SERVICE BULLETIN 45

SUBJECT: POSSIBLE INCORRECT RUDDER PEDAL CENTER SUPPORT BRACKET

APPLICATION: All Glasair II RG aircraft shipped prior to 10/21/87

FIGURE (1)

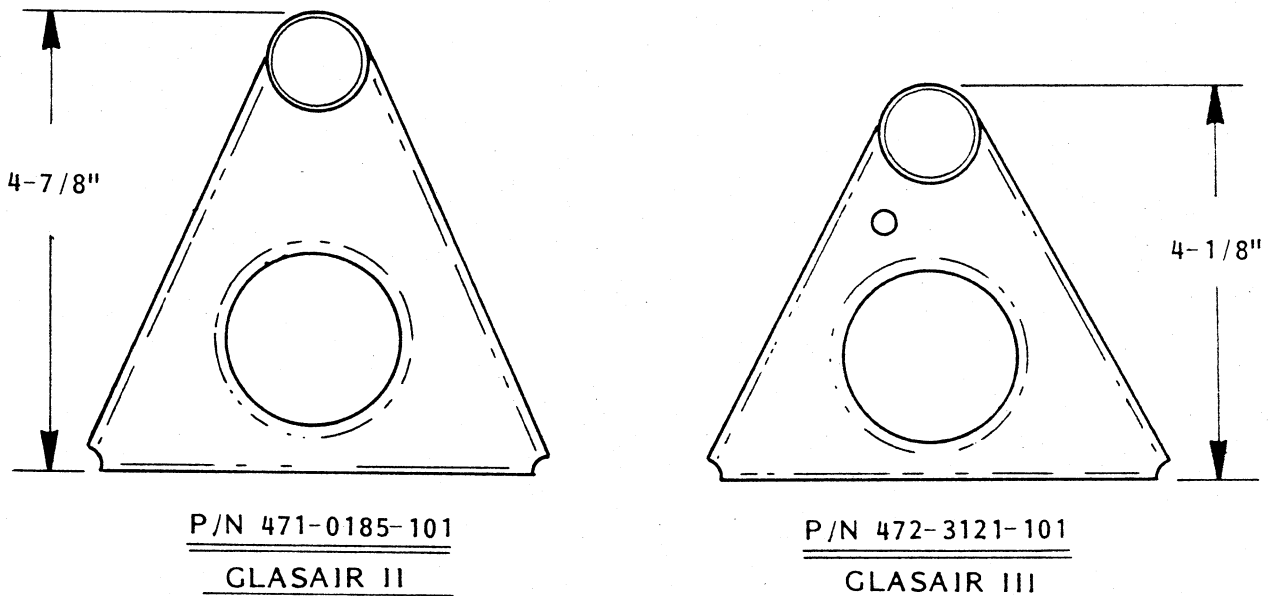
DESCRIPTION: Glasair II RG kits shipped prior to 10/21/87 may have incorrectly included a a Glasair III rudder pedal center support bracket rather than the Glasair II RG center support bracket. The support bracket for the Glasair III (P/N 472-3121-101) looks similar, but is approximately 3/4" shorter than the bracket for the Glasair II (P/N 471-0185-101). The difference in height is due to the different sizes of the nose landing gear boxes on which the brackets are mounted. Use of the shorter (P/N 472-3121-101) bracket on the Glasair II will result in reduced rudder pedal clearance from the upper surface of the forward belly panel.

SOLUTION: Check the rudder pedal center support bracket supplied with your kit against the dimensions provided in FIGURE (1). If you have received the incorrect center support bracket (P/N 472-3121-101), return it to Stoddard-Hamilton Aircraft's Shipping department by 12/31/87 and the correct (P/N 471-0185-101) center support bracket will be sent to you.

NOTE: If you have already installed the rudder pedal assembly using the shorter center support bracket, contact our Builder Support department for assistance.
